RC 2:

The paper describes a new airborne system intended to measure fluxes via eddy covariance and wavelet methods. The paper describes the calibration of the system in detail and presents an example of data taken over Germany. Overall this is an excellently written paper. I think it does a good job of explaining all the different possible errors that go into making turbulent wind measurements from an aircraft. It does not spend much time on the uncertainties in the gas measurements themselves or on additional errors when these instruments are put on an aircraft. I've made some comments about this. The gas measurements are clearly not the focus of this paper and that is fine, but it might be worth pointing that out. At least that uncertainties in the gas measurements have not been evaluated.

Figure RC2.1: Averaged cospectra from flight legs 29th of August 2018 and 21st of August 2019 (in total 11 flight legs were available, for sensible heat only 6 legs were available as no fast Temperature sensor was installed in 2018).

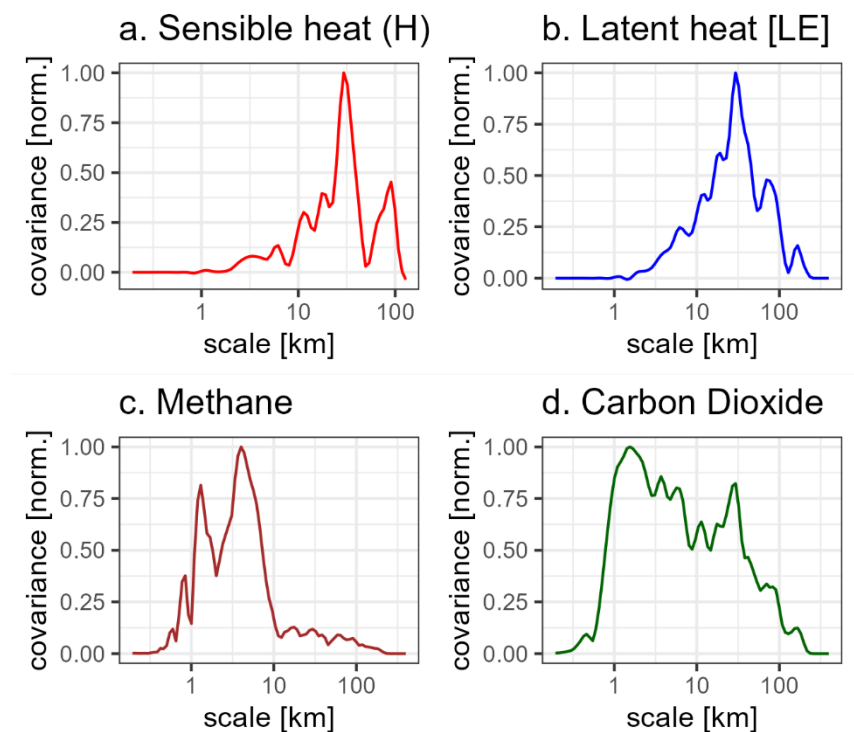
7) Line 620:621: Did you try doing a null experiment to check that the gas measurements are uncorrelated with the wind. In general I didn't see any description of how you calibrated the gas sensors. While in theory the noise should be uncorrelated, there may be changes in alignment, valves (leading to pressure changes), etc. that may correlate with vertical turbulence but may appear to be noise. Running calibration gas through the system and seeing that you get something close to zero flux would show that there really was not correlation between the gas measurement 'noise' and atmospheric turbulence.

Thanks for this suggestion. We did not perform a null experiment to check that the noise was uncorrelated. Nonetheless, the random shuffling method according to Billesbach (2011), which we used for defining the detection limit should probably have revealed such issues. As mentioned also in comment 5 of reviewer 4, a higher level of random noise does generally not affect the covariance, and thus the fluxes, as the noise is not correlated with the vertical motion. This was already shown in detail by Hartmann et al., 2018.

The cospectra that are shown in *Figure RC2.1* clearly indicate that the noise signal that was visible in the spectral plots of the temperature, and Picarro data (*Figure 10b* of the manuscript) is not correlated with the vertical wind and does not cause an artificial flux signal.
